No. EL/3.1.35/2 (TMS)

**Sub:** Minutes of the workshop cum meeting on reliability issues of motor supports fitted in bogies of WAP7/WAG9/WAG9H three phase Electric Locomotives.

**Minutes of the workshop cum meeting held at ELS/GZB on 25.07.2019 on reliability issue of motor supports fitted in bogies of WAP7/WAG9/WAG9H Electric Locomotives**

Figure 1: Different load cases

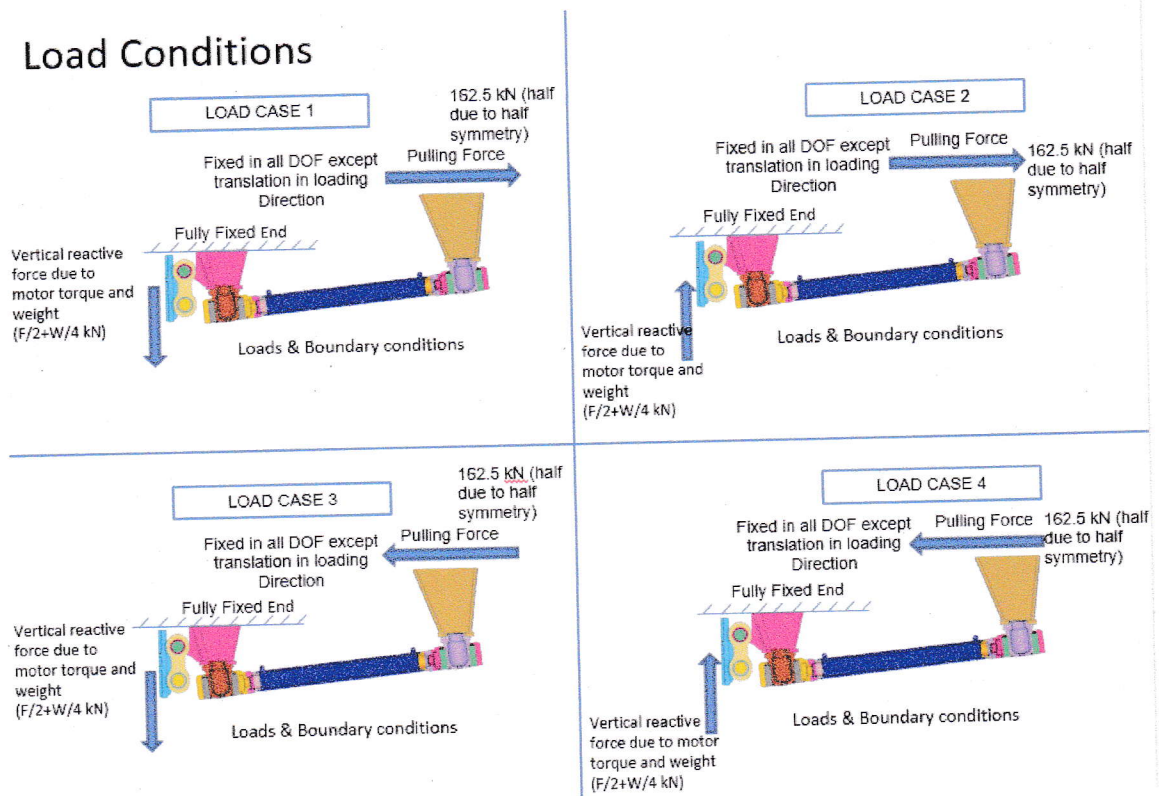
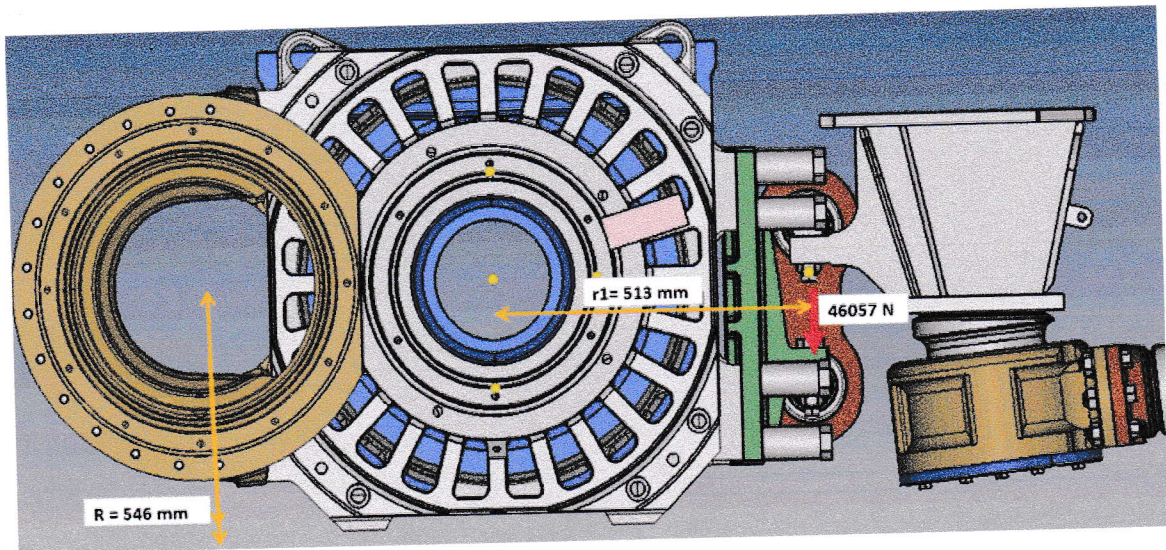
There were 4 combinations of load cases (as described in picture below) for each Iterations.

6. From the above selection, safety sling shall be as under –

1	Force on motor support	
	With 30g shock load	With 100g shock load
	216kN (21.68T)	585kN (58.71T)
2	Safety sling requirement as per IS 2266:2002 (1770 grade, steel core, & 6XV25 construction)	
	Diameter = 19mm Minimum length requirement (as per IS 2762:2009): 19X70=1330mm(1.33m)	Diameter = 32mm Minimum length requirement (as per IS 2762:2009): 32X70=2240mm(2.24m)
3	Safety sling as per SMI 269 Rev. 1	
	Diameter	12mm
	Length for TM1,2,5&6	1510+3mm
	Length for TM3 & 4	1810+3mm

From the above, it is noted that provision of 32mm dia sling is not feasible since it will require a length of minimum 2.24m where requirement is only for 1810mm (max.). However, 19mm sling is feasible but it will only cater the requirement of 30g shock load which is prescribed for bogie mounted equipment as per IEC.

7. All the participants were unanimous that such a heavy cross-section of safety slings are impractical and will not serve the purpose. However, alternate idea of providing suitable brackets on bogie and motor support plate as exists in WAG12 class of loco under trial was discussed.

8. All the OEMs and participants visited shop floor and provision of bracket was examined by detailed inspection of bogie placed on a pit line. It was noted that it is feasible to provide 'D' bracket on bogie transom and 'L' type bracket on traction motor mounting plate. In normal position, there will be a gap between 'D' and 'L' bracket. In case of breakage of traction motor support, motor will rest on 'L' bracket and prevent it falling on track.
